## **CITY OF SALINAS PLANNING COMMISSION STAFF REPORT**

**TITLE:** **CONDITIONAL USE PERMIT 2020-001; REQUEST FOR RESIDENTIAL DESIGN REVIEW TO CONVERT 965 SQUARE FEET OF AN EXISTING 1,099 ATTIC INTO A SECOND STORY ADDITION WITHIN AN EXISTING SINGLE-FAMILY DWELLING UNIT LOCATED AT 1054 UNIVERSITY AVENUE IN THE R-L-5.5 (RESIDENTIAL LOW DENSITY) ZONING DISTRICT**

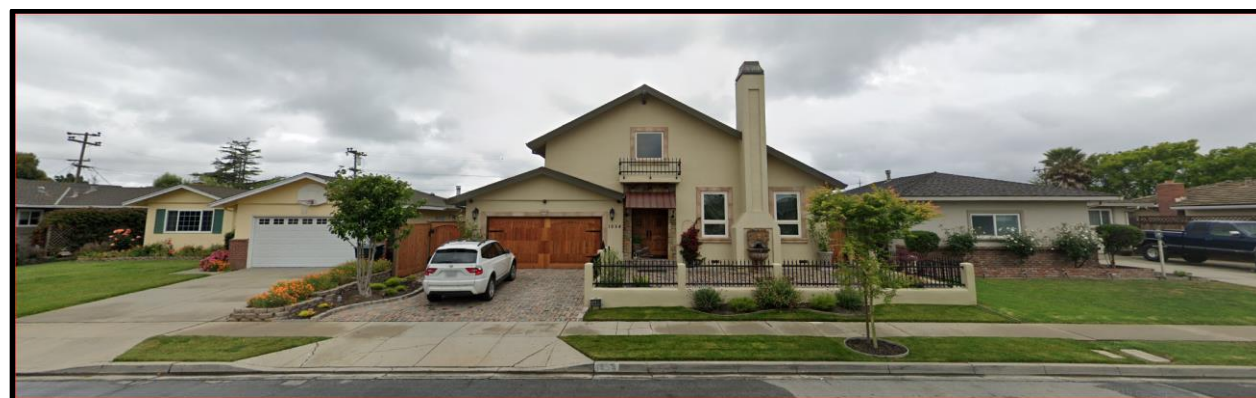
1. Demolishing 134 square feet of extraneous second floor area by removal of interior attic partition walls;
2. Frosting of dormer windows; and
3. Adding the following: stone veneer around main entry door, copper seam metal roof porch with copper columns extended into front yard setback over main entry door, and decorative steel grill and wood corbels under attic window facing the street.

***Analysis:*** Adding stone veneer around main entry door, a copper seam metal roof porch with copper columns over main entry door, and decorative steel grill and wood corbels under attic window facing the street appears not to address the Planning Commission's direction to minimize the scale and bulk of the second story addition and/or address articulation opportunities.
